From: [Al Petrie](#)
To: [Murray, Susie](#)
Cc: [Marsha Chevalier](#)
Subject: [EXTERNAL] Bike Lane planning on San Miguel and effect on Kerry Ranch 1
Date: Thursday, August 4, 2022 4:53:17 PM
Attachments: [KERRYranchBIKElanesHandwritten_2022-08-04_164912.pdf](#)

The Thursday, August 11th, 2022 discussion, per the Public Hearing on Kerry Ranch 1 - Parcel "A", should/will involve the question of re-striping San Miguel to eliminate the Bike Lanes and thereby adding a parking lane on the north side of San Miguel abutting Kerry Ranch 1 - Parcel "A".

SMALL LOT SUBDIVISION: PARCEL A KERRY RANCH

PRESENTATION TO THE PLANNING COMMISSION: AUGUST 11, 2020 PUBLIC HEARING

COUNTY ASSESSOR'S PARCEL MAP

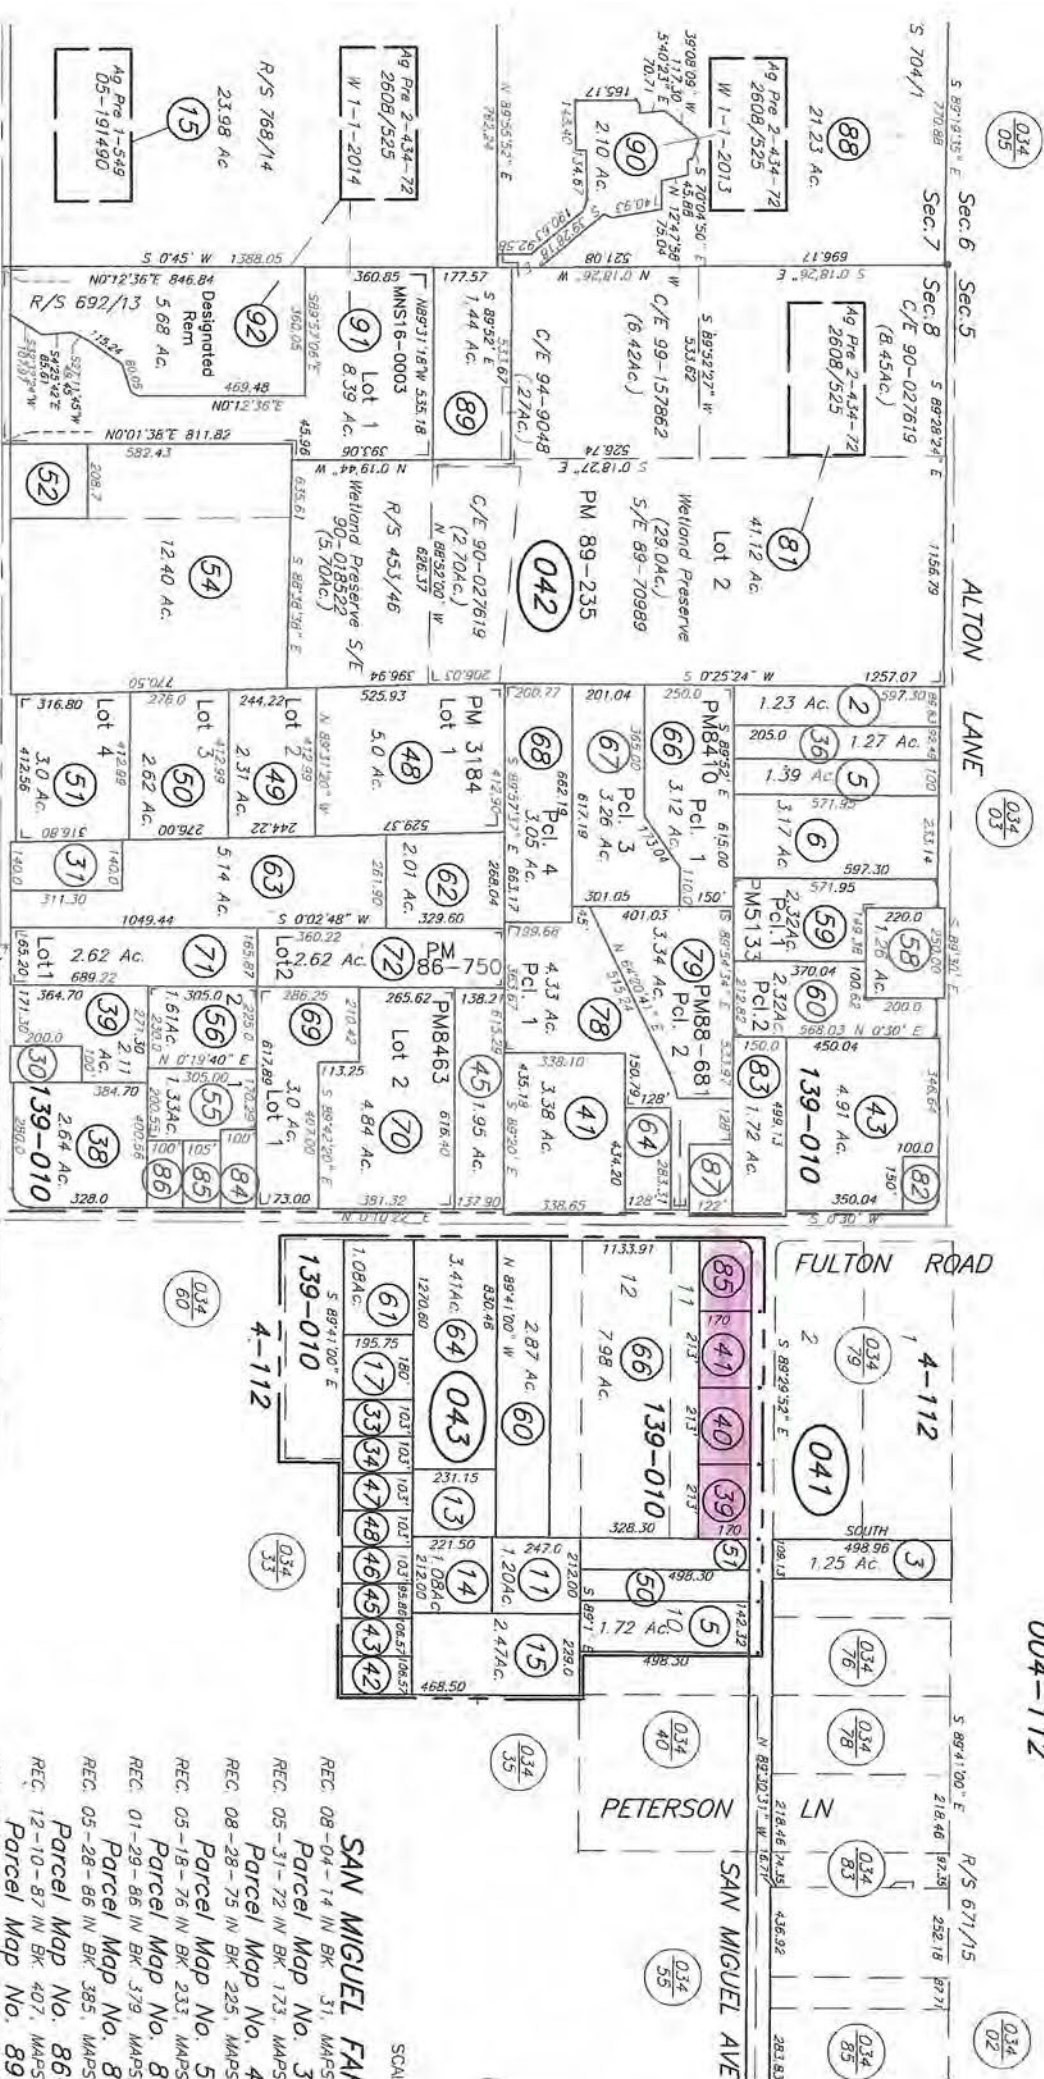
I took some measurements today to see if it's feasible to widen San Miguel the last 800 feet before Fulton Road to accomplish a curb to curb width of 46 feet (thereby provide 8-foot parking lanes on both sides of the street, 5-foot bike lanes on both sides of the street, and two 10 foot travel-way lanes in the street). The attached County Assessor's map (showing the questionable 4 parcels in red) and the attached sketch clearly shows that the existing 28 foot wide street in this section of San Miguel can not be widened to 46 feet within the current public right of way. In fact, the City would need to gain control of approximate 10 feet of private right of way on the south side of San Miguel to accomplish this purpose.

Three of the four lots on the south side of San Miguel are fully developed (and in the County unincorporated area I believe) and would have no incentive to dedicate 10+ feet off of the front setback of their property to accomplish the City purposes of re-development of San Miguel Avenue to a 46 foot curb to curb width!!

Therefore, why is the City of Santa Rosa pushing the installation of bike lanes on the eastern section of San Miguel at Francisco Avenue, when parties using these bike lanes would be left to "blend in" with vehicle traffic at approximately 800 feet before San Miguel reaches Fulton Road??? The NWSRNA is of the belief that installation of bike lanes on Francisco Avenue from San Miguel to Fulton Road is a much better alternative since this route has much lower vehicle traffic (there is a fire gate at Jack London School that stops vehicle traffic but provides for bikes passing through) and the County just improved Francisco Avenue, in the County controlled area, such that this route offers much greater safety to bike riders.

Existing curb
 face on north
 side of San
 Miguel

28' foot
 width of
 San Miguel

46' WETTED FOR
 Future Roadway
